ADDENDUM NO. 2 – January 9, 2025

**Valverde Park Renovation – CIP PK 24-04
Mossdale Park Renovation – CIP PK 25-01**

This addendum amends the Contract Drawings and Specifications for this project as follows:

SHEET
L6.1

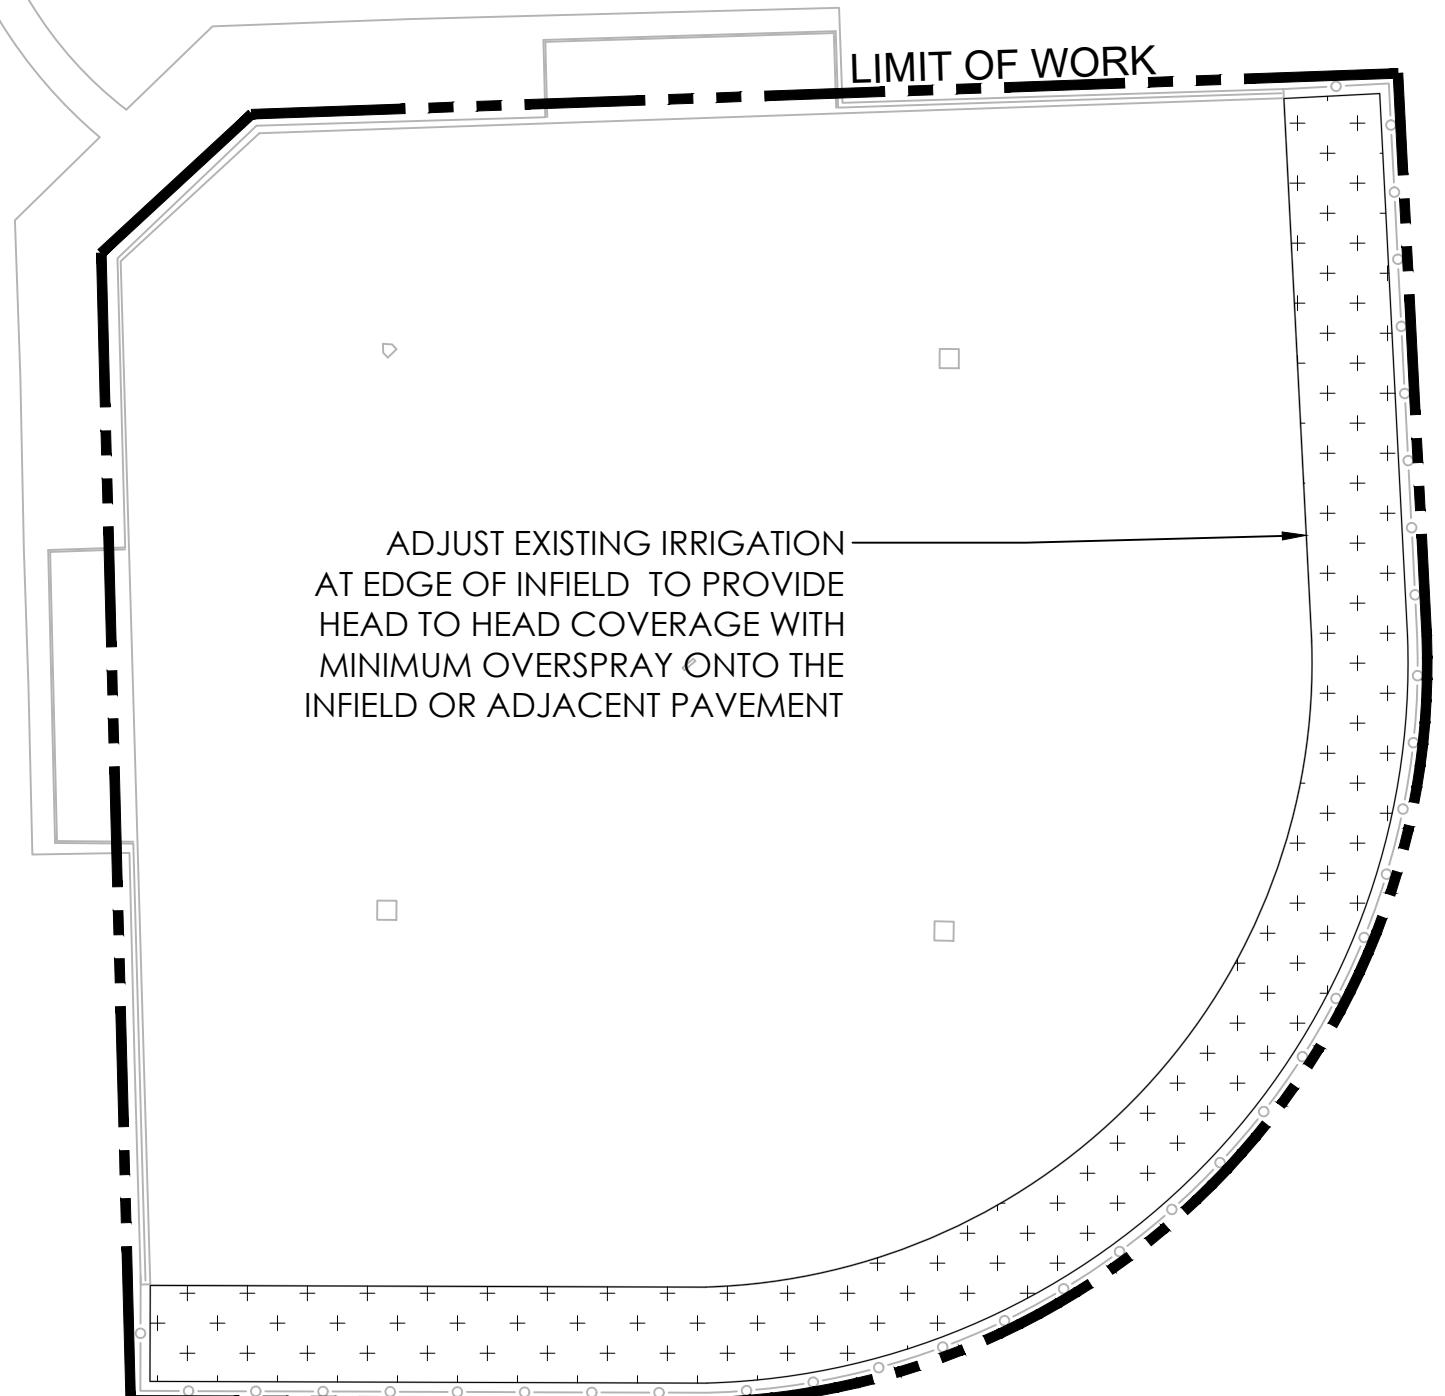
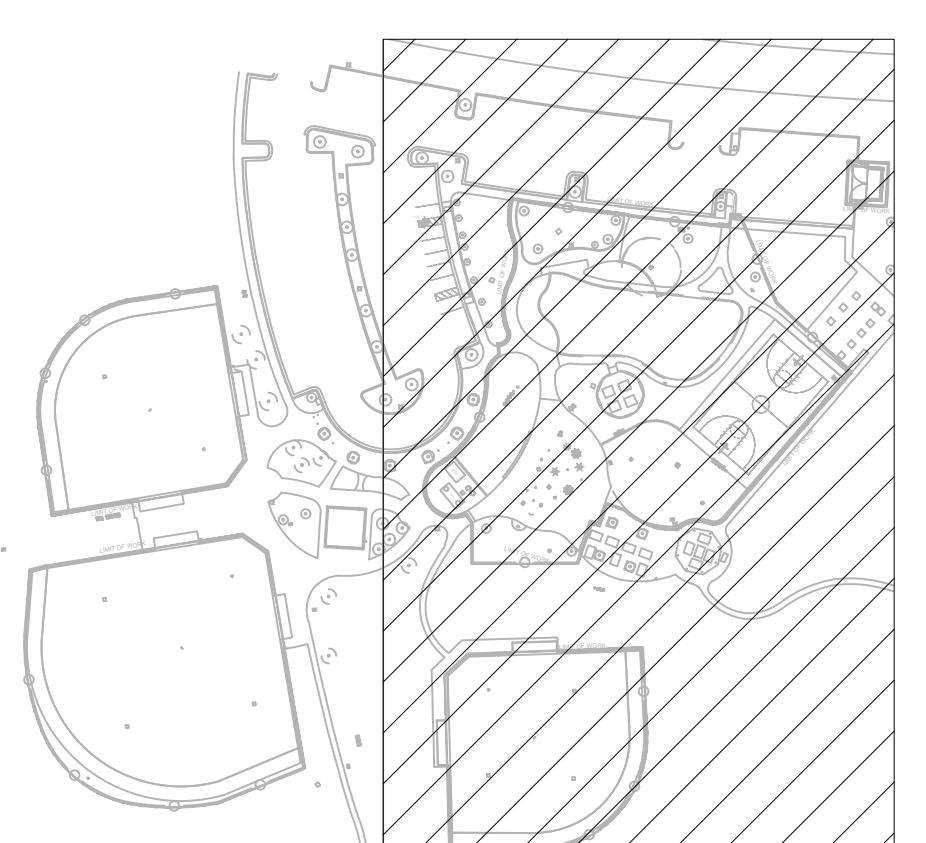
RFI 2: Refer to L6.1, The note schedule "I-08" states the replacement of valve B27 with a new drip zone control kit. The contractor needs to reconnect control wires from the existing valve B27, but it is not shown on plans. Please confirm if the existing valve is at the same location of the proposed valve. If not, please provide its location for reconnection of wires.

SHEET L6.1– MOSSDALE LANDING PARK – IRRIGATION PLAN (IRRIGATION LEGEND): Description of Remote Control Valve changed to “REMOTE CONTROL VALVE: RAIN BIRD PESB-R INDUSTRIAL REMOTE CONTROL VALVE, GLOBE CONFIGURATION WITH SCRUBBER TECHNOLOGY, SIZE PER PLANS.”

SHEET L6.1– MOSSDALE LANDING PARK – IRRIGATION PLAN (IRRIGATION LEGEND): Symbol for Drip Remote Control Zone Kit updated and description changed to “DRIP REMOTE ZONE CONTROL KIT: RAINBIRD XCZ-150-LCDR”

SHEET L6.1– MOSSDALE LANDING PARK – IRRIGATION PLAN: Updated Valve type symbols.

SHEET L6.1– MOSSDALE LANDING PARK – IRRIGATION PLAN: Change Proposed Valve B19 size to 1.5”

SHEET L6.1– MOSSDALE LANDING PARK – IRRIGATION PLAN: Change Proposed Valve B18 size to 1”

SHEET L6.1– MOSSDALE LANDING PARK – IRRIGATION PLAN: Change Proposed Valve B28 size to 1.5”

A2: New Drip Zone Control Kit (B27) will replace existing valve B27 in the same location.

SHEET
L12.0

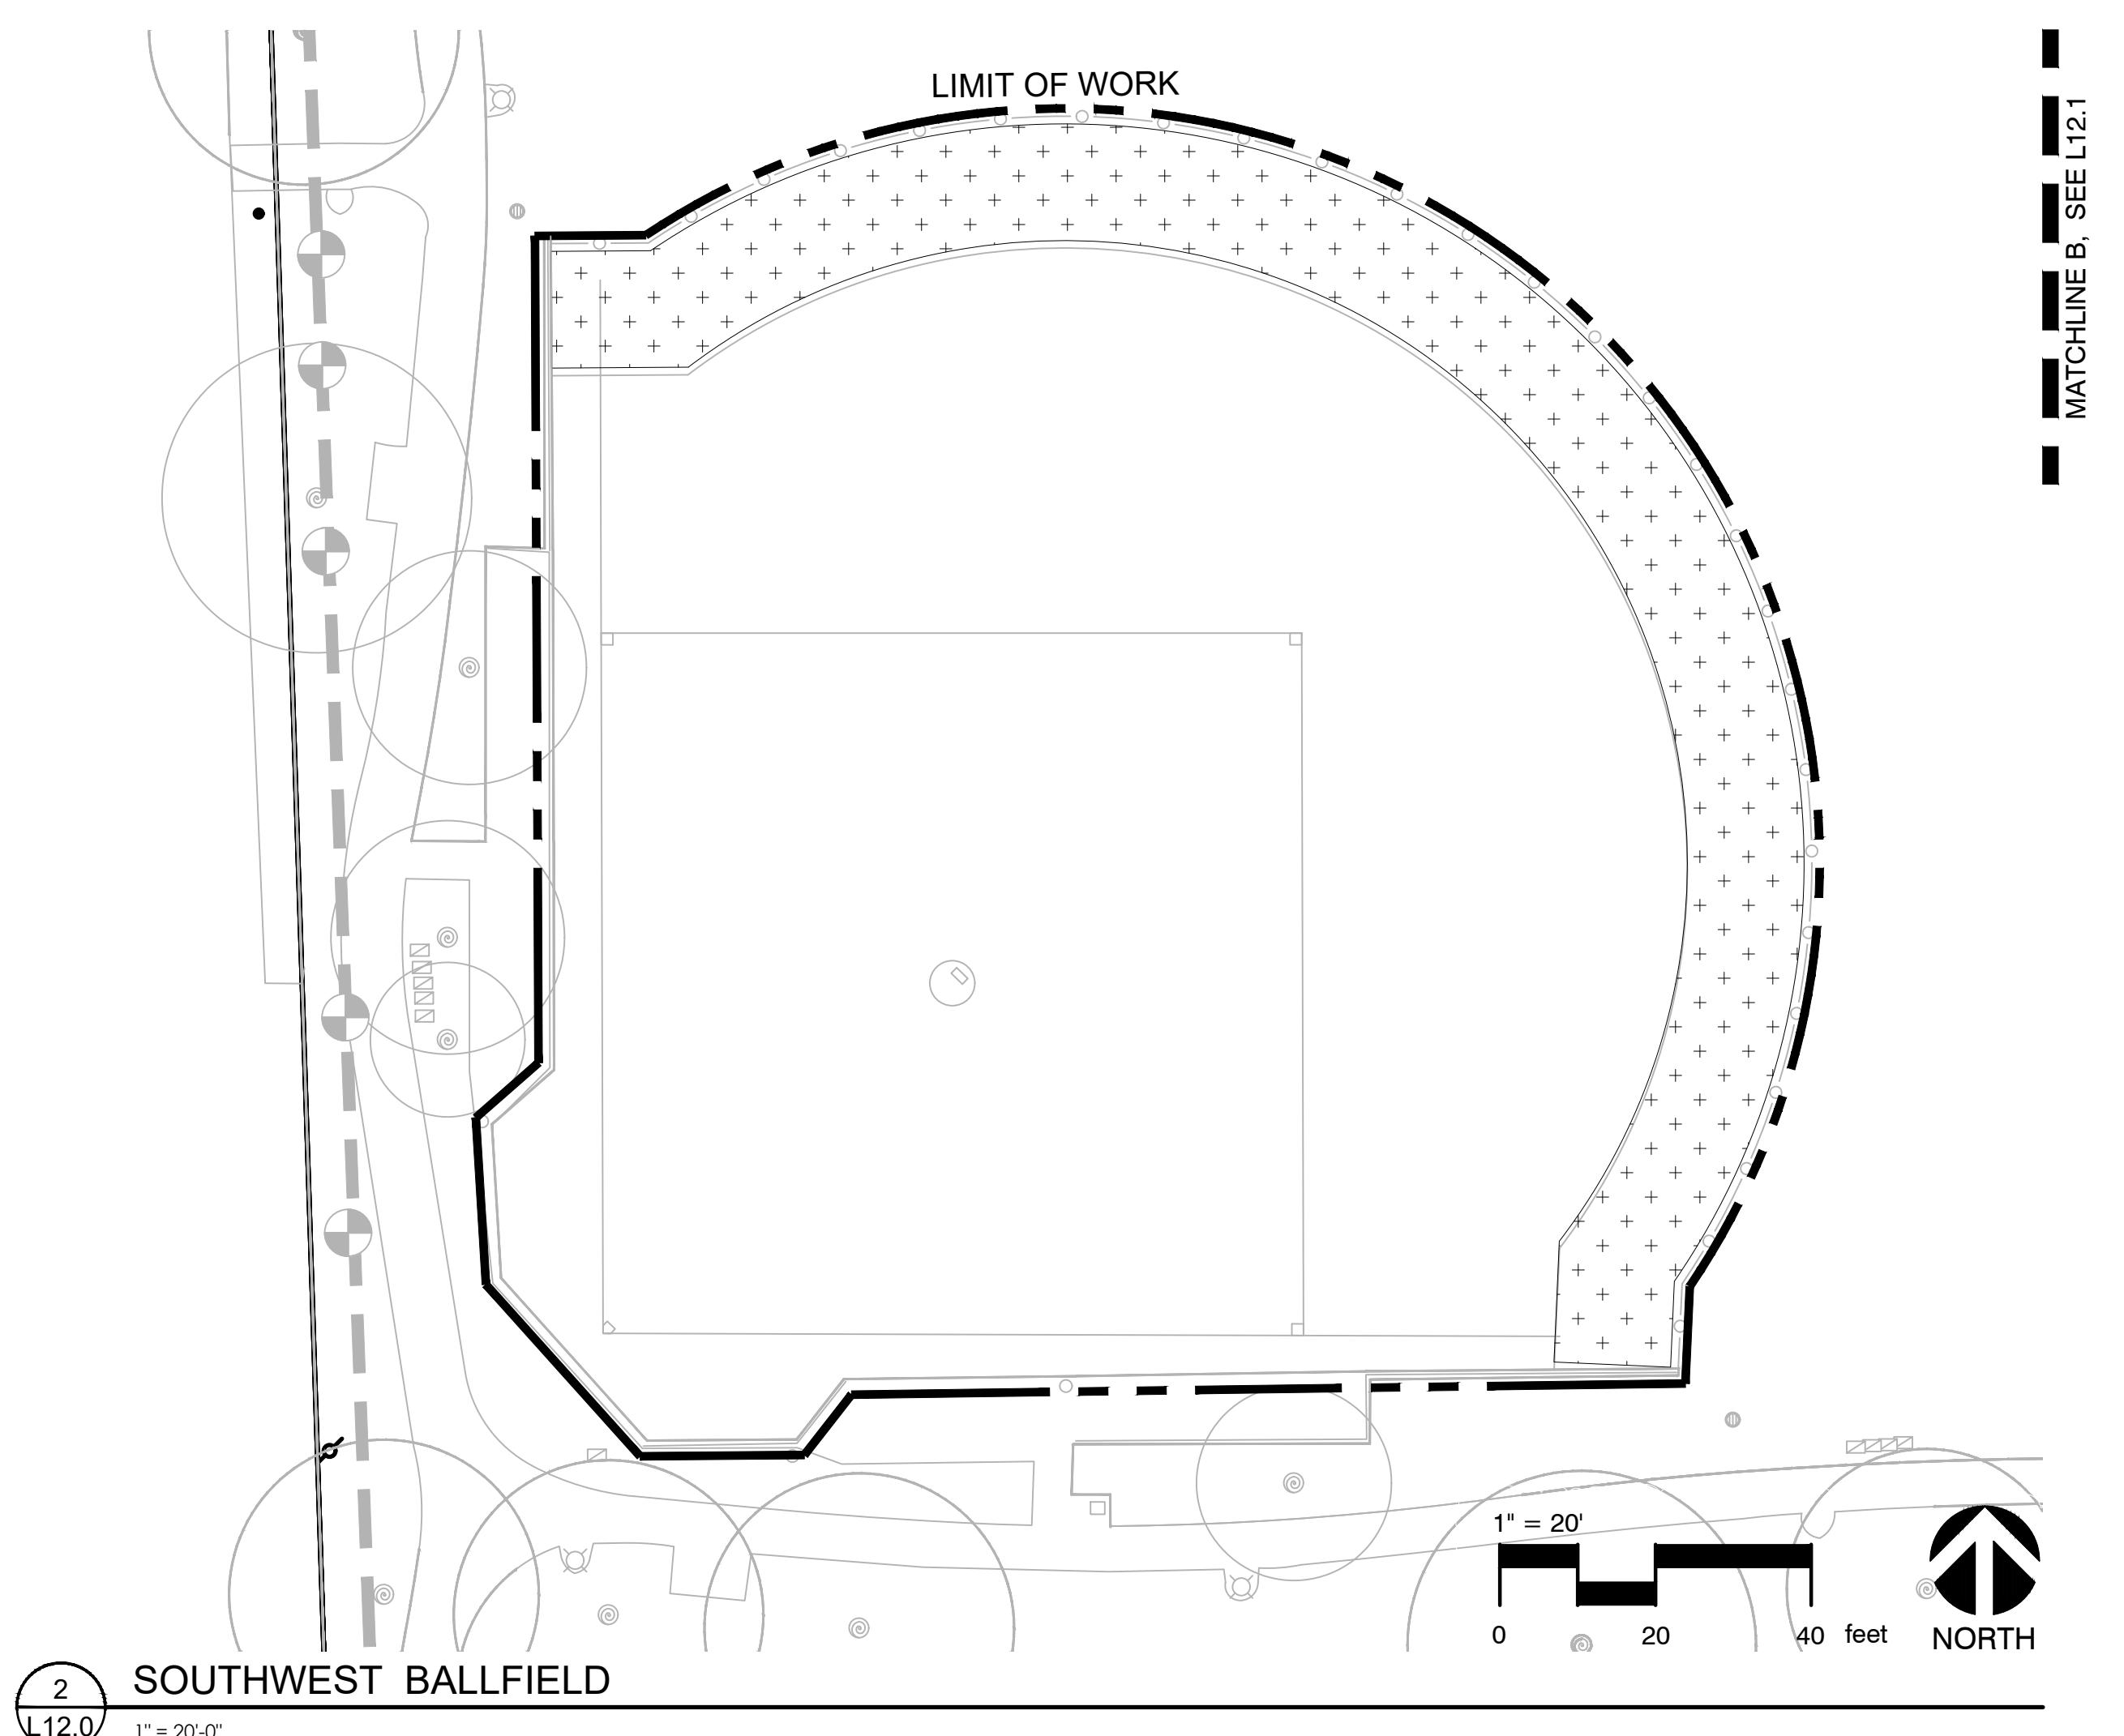
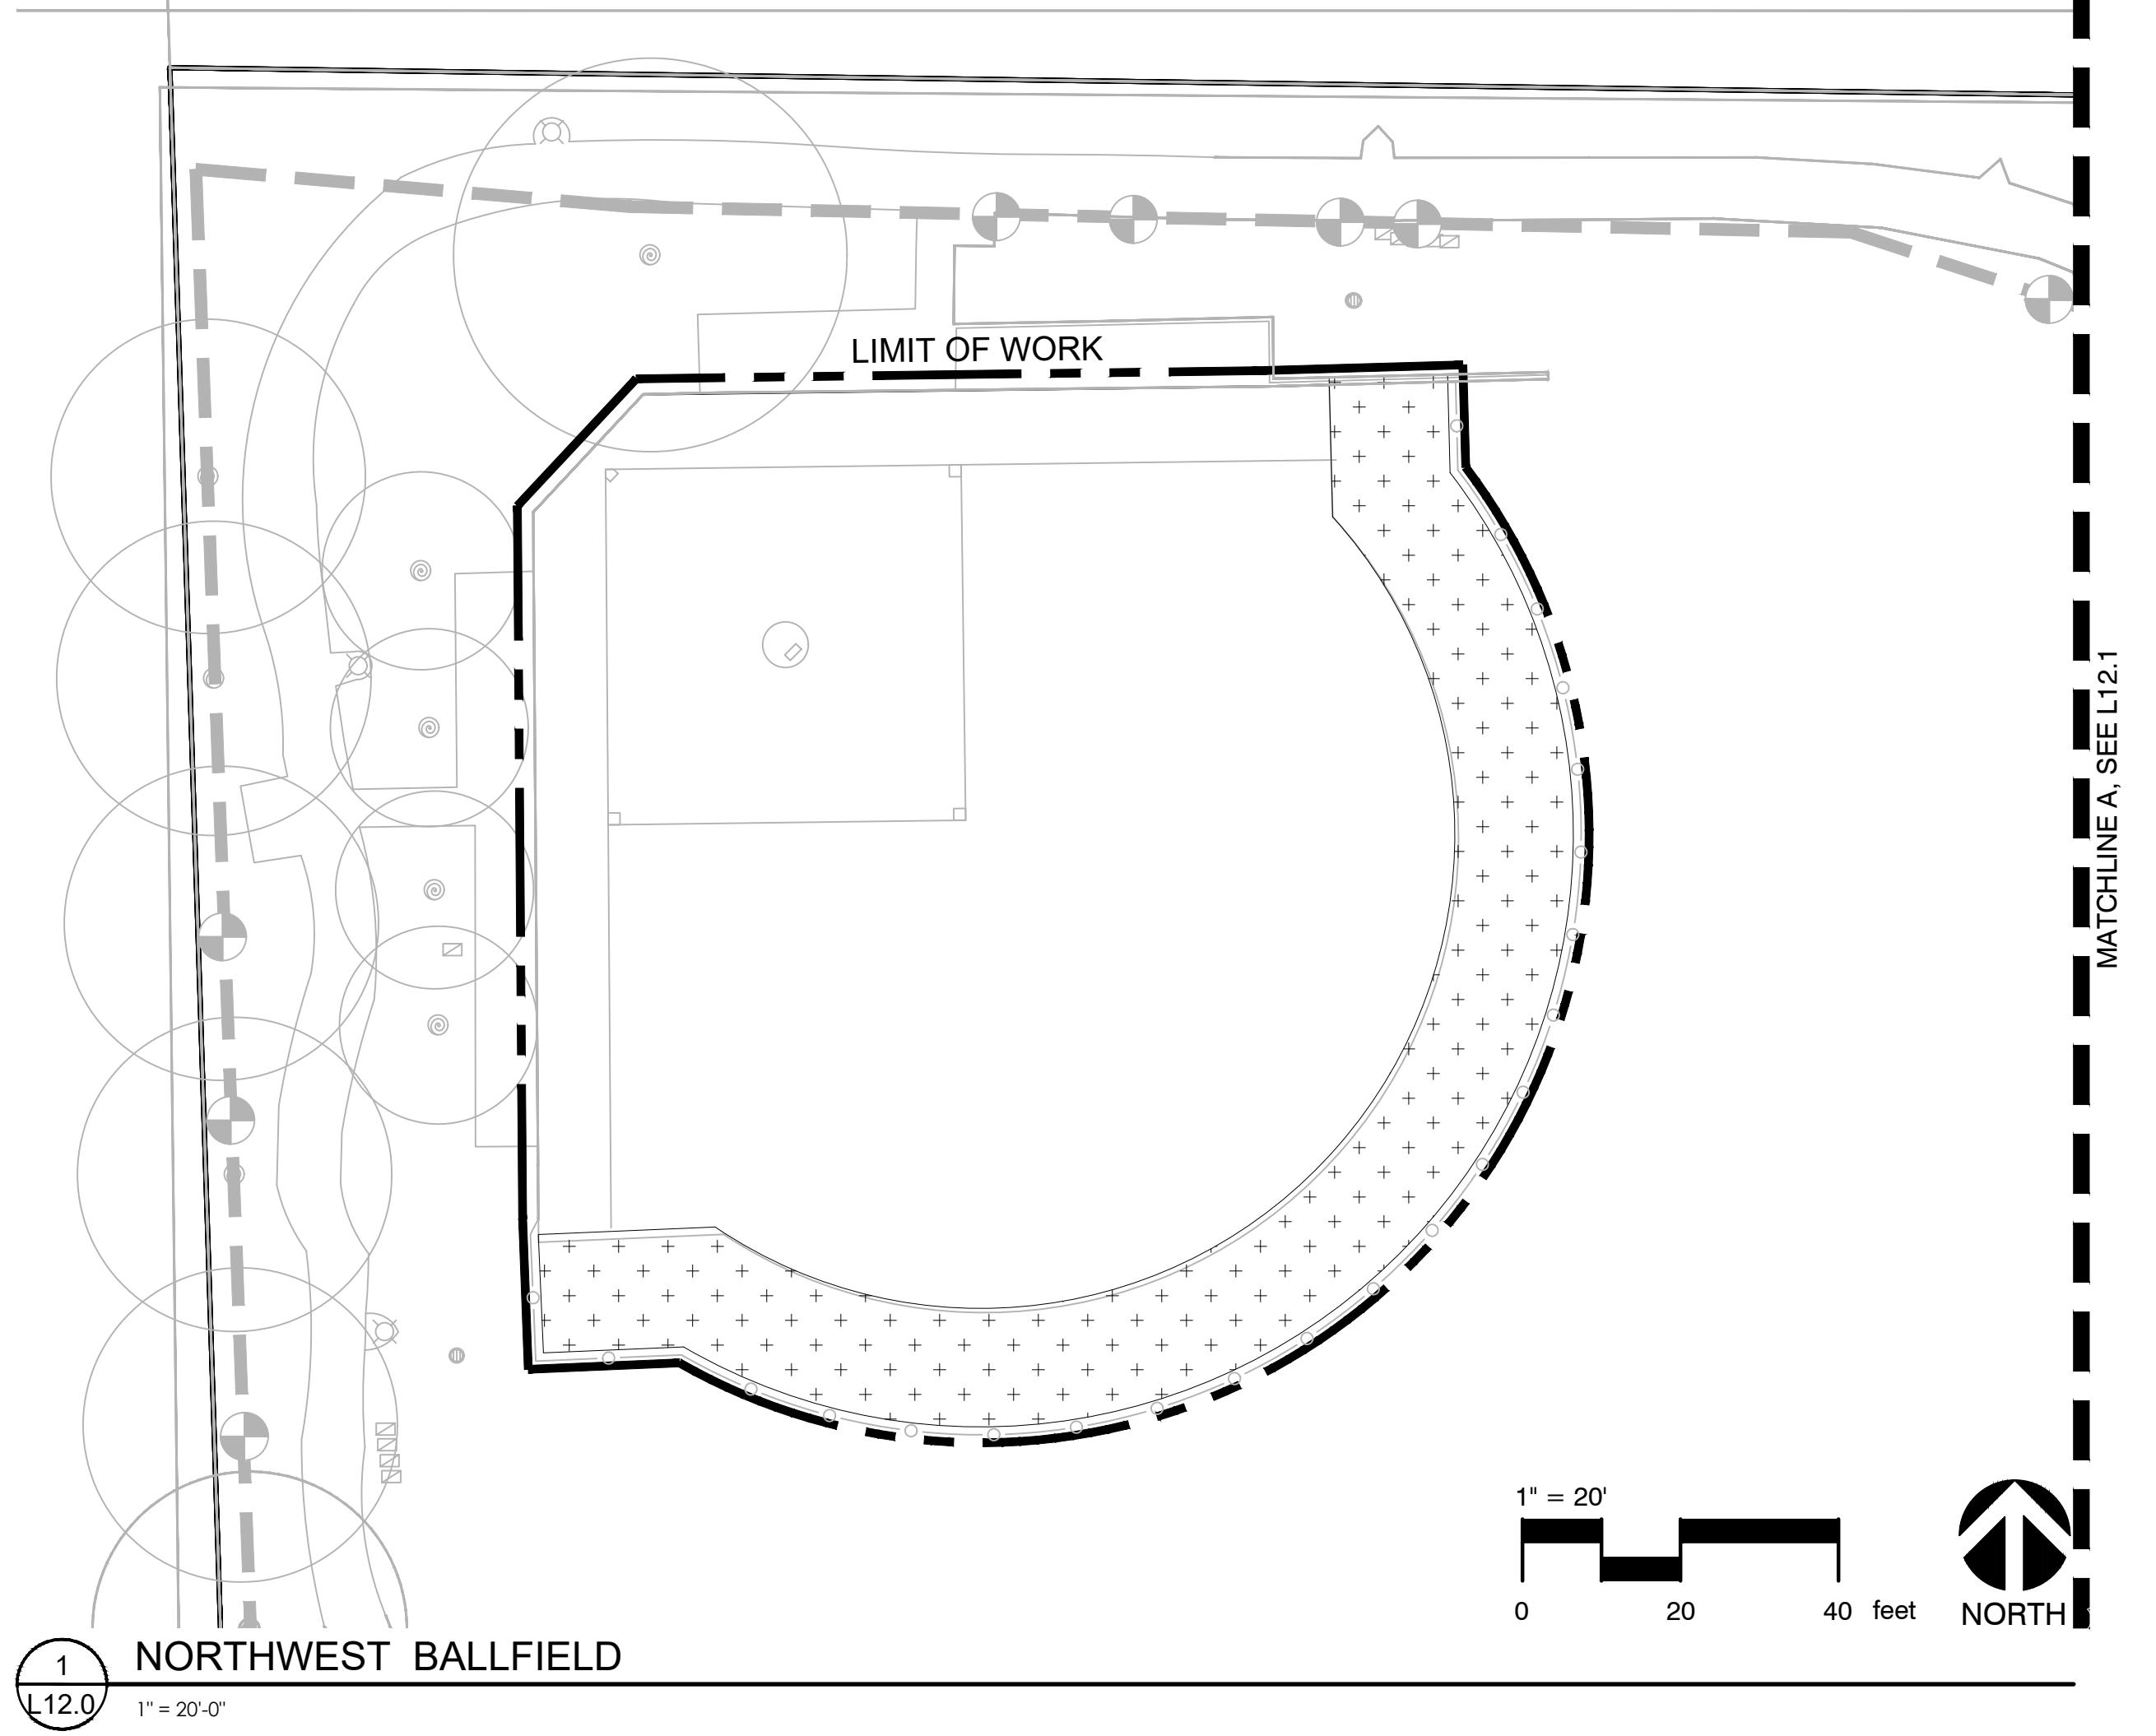
SHEET L12.0– VALVERDE PARK – IRRIGATION PLAN (IRRIGATION LEGEND): Updated symbol for Drip Remote Control Zone Kit.
